Washington Metrorail Safety Commission

Inspection Date	YYYY	MM	DD	Report Number	20200716-WMATA-LBW-1		
	2020	07	16				
Rail Agency Name	Washington Metropolitan Area Transit Authority			Rail Agency Department	Operations	Sub-Department	Stations
Rail Agency Department Contact Information	Name		Email		Office Phone		Mobile Phone
	[REDACTED]		[REDACTED]		[REDACTED]		[REDACTED]
	[REDACTED]		[REDACTED]		[REDACTED]		[REDACTED]
	[REDACTED]		[REDACTED]		[REDACTED]		[REDACTED]
Inspection Location	Arlington Cemetery (C06)

Inspection Activity #	1	Inspection Subject	Station Assessment – Arlington Cemetery (C06)				Activity Code	RTRA	GEN	RR	
Job Briefing Employee Name/Title	NA		Accompanied Inspector?	NA	Out Brief Conducted	NA	Time	NA	Outside Shift	NA	
Related Reports	N/A		Related CAPS / Findings		NA						
Related Rules, SOPs, Standards, or Other	Ref		Rule or SOP		Standard		Other / Title		Checklist Reference		
Inspection Location	Main Track	Yard	Station	OCC	RTA Facility	WMSC Office	Track Type	At-grade	Tunnel	Elevated	N/A
			X			X		X			
Line(s)	Charlie		Track Number		Chain Marker and/or Station(s)		From		To		
Vehicles	Head Car Number		Number of Cars		Equipment						
Description	The WMSC Inspector

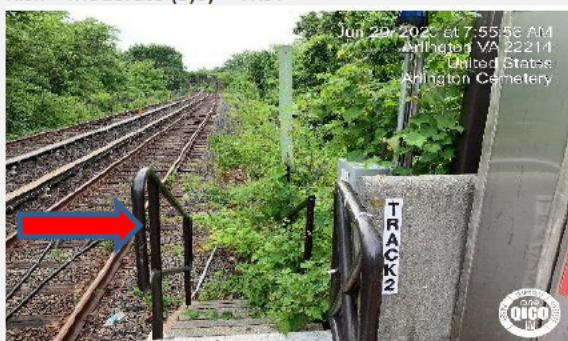
4. Ponding water on platform (Various locations)

Risk – Moderate (3,3) – PLNT
